Section 42A Officer's Report

Hearing Stream 6: Infrastructure

Subject: **Transport (this report)**
Infrastructure
Protection of Infrastructure
Renewable Energy Generation
Three Waters

Report date: 24 August 2026

Figure 2: Visibility splays and safe stopping distances

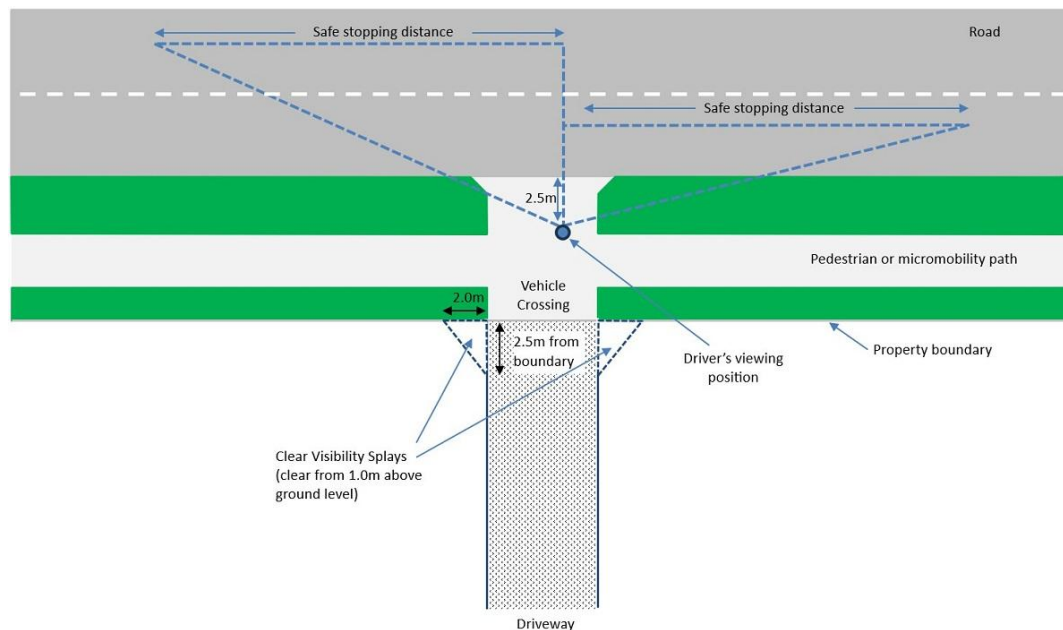
- (147) Z Energy (468.154) and the Fuel Companies (471.146) support the standard and seek that it is retained as notified.
- (148) Hutt Cycle Network (251.9) supports standard TR-S6 in part, but seeks the following modifications:
5. *For ~~pedestrian the~~ safety of pedestrians, people on bikes and micro mobility users, vehicle crossings must have clear visibility splays from 1.0m above ground level, as shown in Figure 2: Visibility splays and safe stopping distances.*

- (149) The text at the beginning of clause 5; “For pedestrian safety,...” is there as context for plan users to understand the intent of the clause. While I do not disagree with the Hutt Cycle Network (251.9), that the visibility splay requirement also protects other active mode uses, I do not think that these users need to be specified to aid the implementation of the clause and potentially adds clutter to the provision.

- (150) I do not consider the additional text “...or if convex mirrors or other monitoring and visibility devices are installed” is appropriate to include in a standard as it is too open-ended. The suitability of these devices as alternatives to visibility spays / speed bumps will be very context dependent, and are better assessed on a case-by-case basis through the resource consent process. I consider that clause 5b requested by Hutt Cycle Network (251.9) is already achieved by the standard as written, through the reference to TR-Figure 2 in TR-S6.5.

Figure 3 — Motor vehicle parking

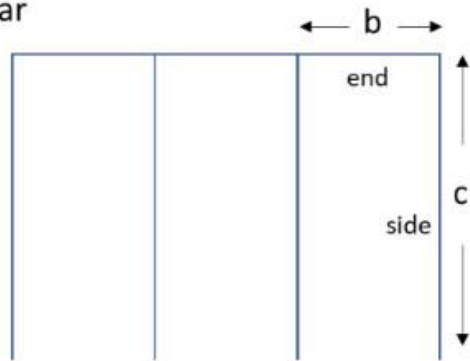
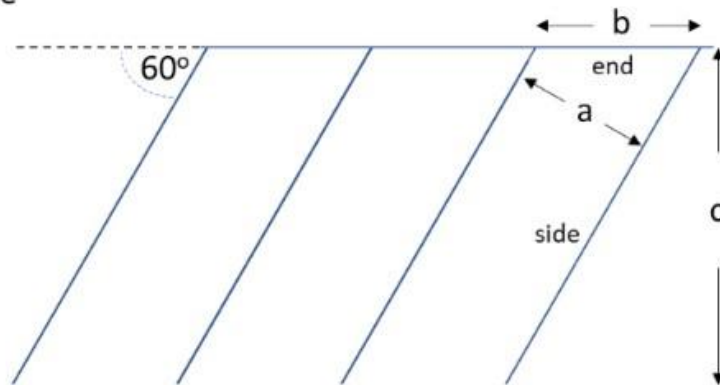
(178) Ms Skilton (314.72) also seeks the following relief in relation to TR-Figure 3 and TR-Table 5:

- That they reflect the NZS 2890.1 update,
- That the dimension marked "b" in the diagram of parallel and perpendicular parking spaces in TR-Figure 3, is marked as "a" to be consistent with the angle parking diagram,

- Clarify that the minimum aisle width is manoeuvring space, and
- Simplify the table.

- (186) The submission of Ms Skilton (314.72) requests that the TR-Table 5 and TR-Figure 3 are reviewed to reflect an update to AS/NZS 2890.1. My understanding is that there has been consultation to review the AS/NZS standard, and that this review was considering changes necessary to accommodate a larger vehicle fleet. At the time of this report, no updates to the standard which reflect this review process have been published, and what has been included in the PDP reflects the latest version of the AS/NZS 2890.1 (with the exception noted above).

- (187) Ms Skilton (314.72) seeks clarification that manoeuvring space requirements are provided for within the aisle width requirements of TR-Table 5. I confirm that this is the case. I consider it would be useful clarification to modify clause 2, to inform plan users that the requirements for manoeuvring space are contained within TR-Table 5.

(180) Regarding the point on terminology raised by Laura Skilton (314.69, 314.73), I agree that it is better to use consistent terminology through TR-S8, TR-Figure 3 and TR-Table 5. 'Carparking' is a term with a definition which supports its use in zone chapter provisions. However, this definition would not support the interpretation that is intended for the provisions for the design of parking spaces in the TR chapter. Therefore, I consider it better to use the words "motor vehicle parking spaces" to describe the provisions in TR-S8, TR-Figure 3 and TR-Table 5.

- (185) Regarding the Go Architecture submission (331.6), the standard TR-S8, through TR-Figure 3 and TR-Table 5, mostly incorporates the requirements of AS/NZS 2890.1. The one exception, is that for perpendicular parking spaces of 2.5m width, a reduced aisle width requirement (5.4m) applies in TR-Table 5, which is different to the 5.8m which applies in AS/NZS 2890.1 regardless of whether perpendicular spaces are 2.4m or 2.5m wide. This provides applicants with greater flexibility in designing parking and manoeuvring on-site while ensuring park spaces can be safely accessed.

- (188) While I acknowledge Ms Skilton's point (314.72) concerning the complexity of TR-Table 5, I consider that this is somewhat unavoidable in incorporating the requirements of AS/NZS 2890.1. The presentation of parking design requirements in TR-Figure 3 and TR-Table 5 is consistent with that of the Wellington City and Porirua district plans.
